UNITED STATES PATENT AND TRADEMARK OFFICE

APPLICATION NO.	FILING DATE	FIRST NAMED INVENTOR	ATTORNEY DOCKET NO.	CONFIRMATION NO.
10/679,156	10/03/2003	Frederick H. Grenning	5320/55488	3953

Office Action Summary

Fig. 1

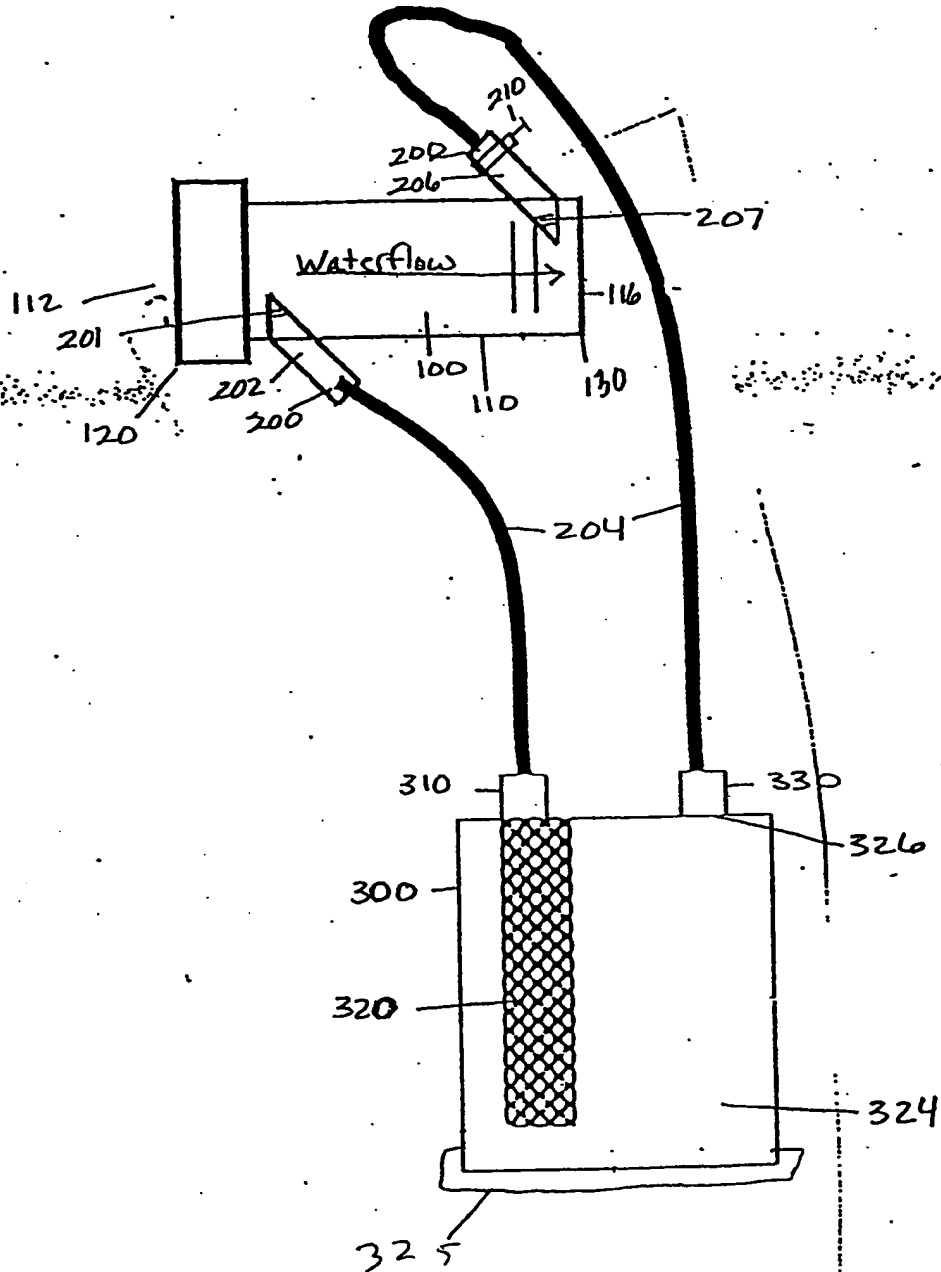
which is not supported by the original disclosure is as follows: the removable access cap 325 added to FIG. 1 and 325a added to FIG. 4 is new matter; the limitations relating to the access cap added to pages 13, 14, 16, and 18 of the specification.

Do not enter
ms

Applicant is required to cancel the new matter in the reply to this Office Action.
